**ADDENDUM NO. 5
TO
CONTRACT DOCUMENTS, SPECIFICATIONS AND PLANS
FOR IMPROVEMENTS TO THE
ST. JOSEPH ROSECRANS MEMORIAL AIRPORT
ST. JOSEPH, MISSOURI
MODOT PROJECT NO. 22-012A-1**

To All Bidders: You are requested to make all changes and/or additions contained in this addendum to the Bidding Documents. Failure to acknowledge this Addendum in Proposal shall result in rejection of bid. Bidders are informed that the above referenced Questions with Corresponding Answers, Contract Documents, Specifications, and Plans are modified as follows as of December 7, 2022.

SUPPLEMENTAL DRAWINGS FROM AS-BUILTS

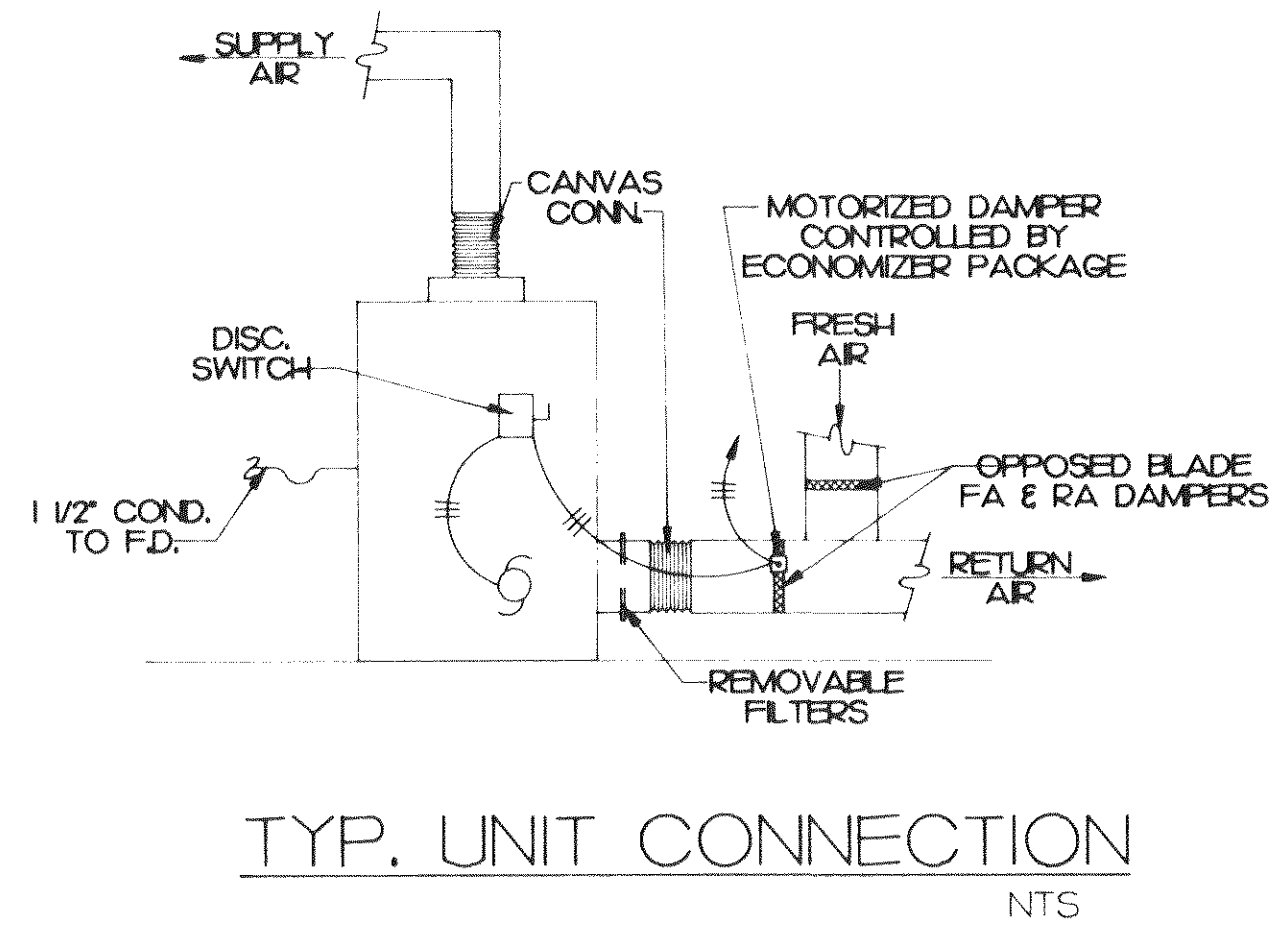
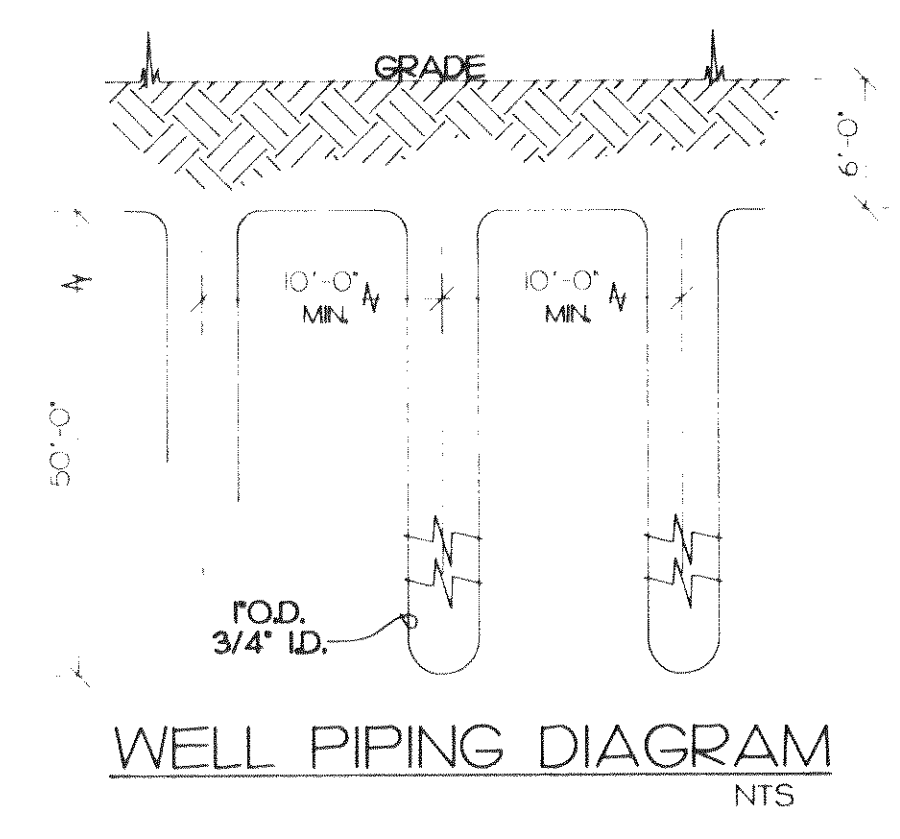
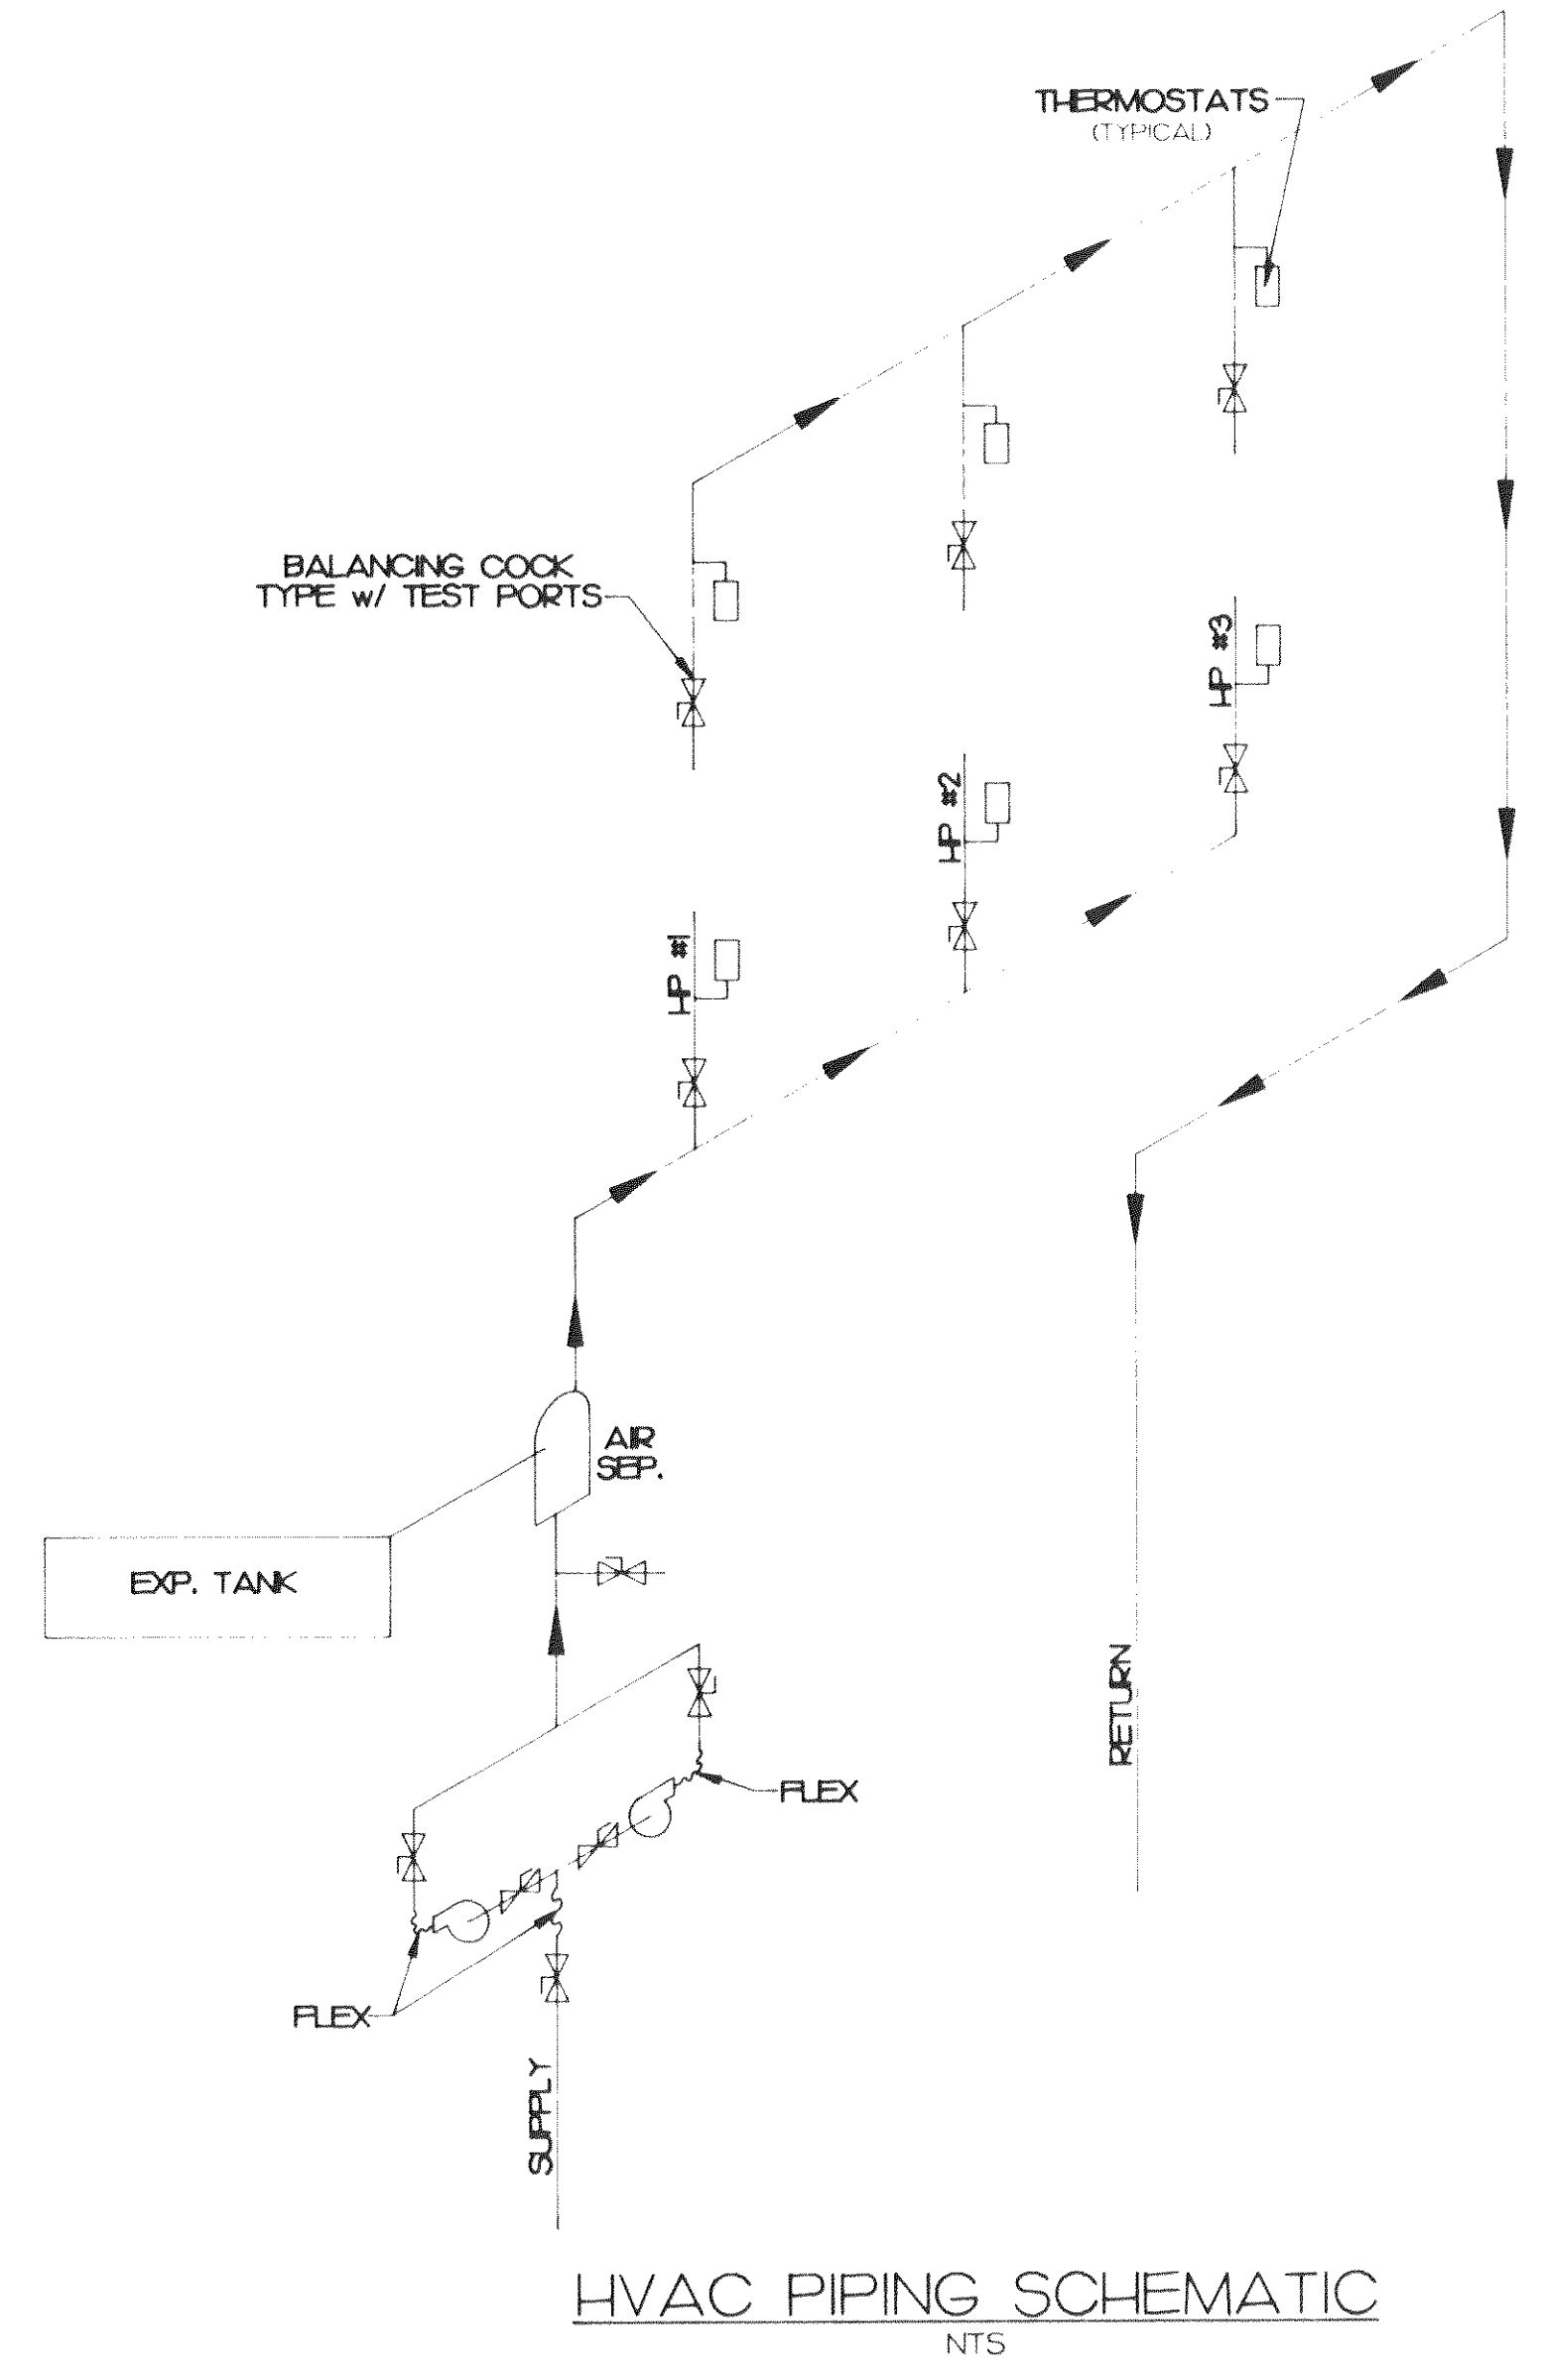
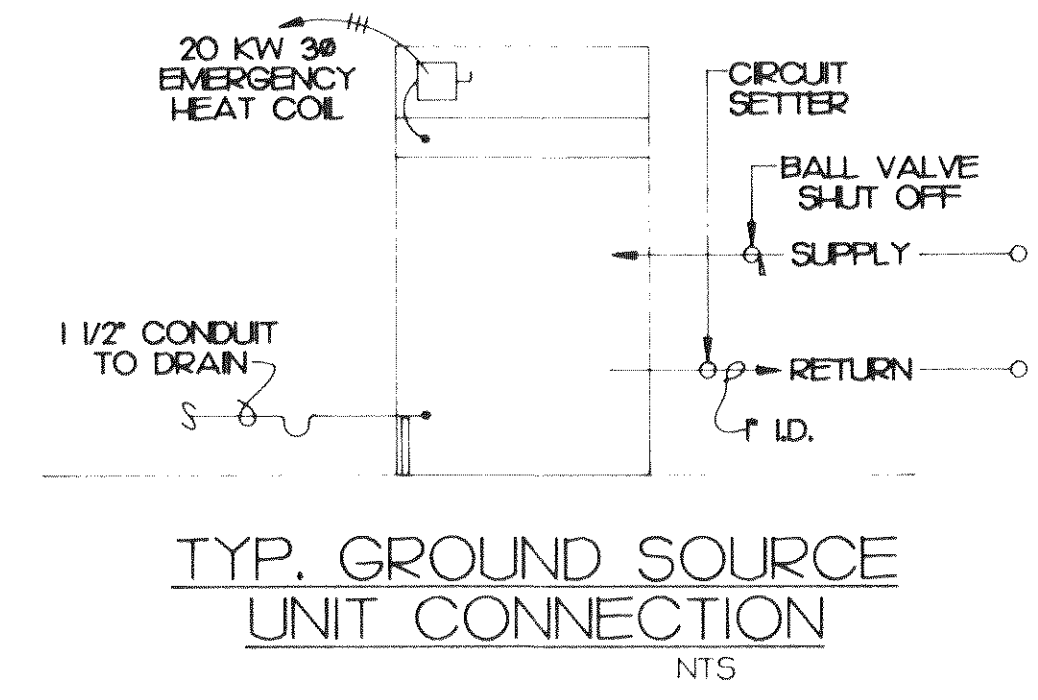
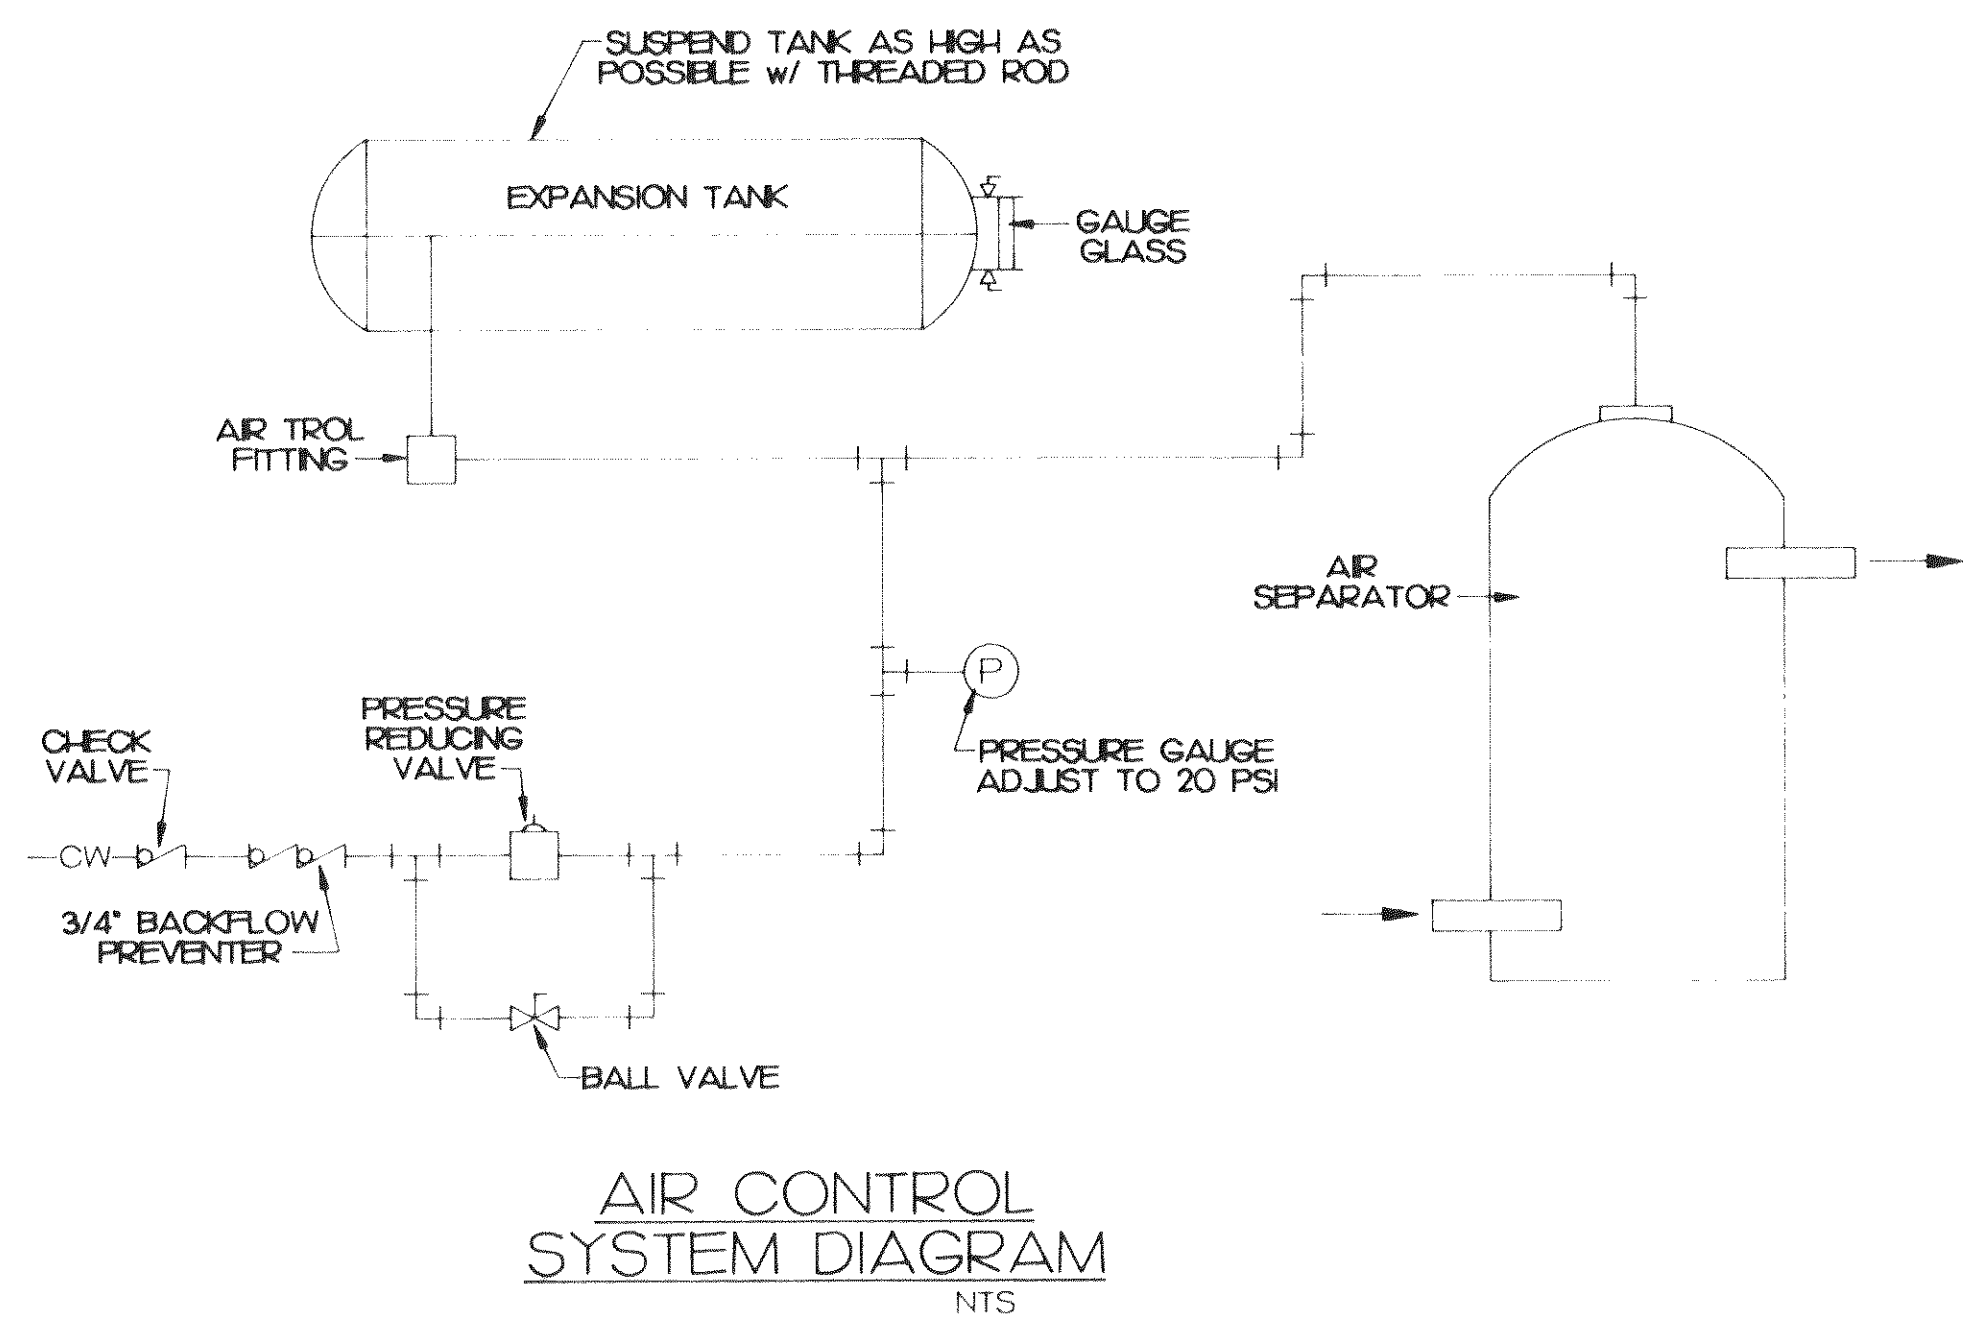
7. Is there any information or drawings for the existing Well Field that is to be removed?
 - a) Please see attached supplemental as-built Well Field Drawing information.
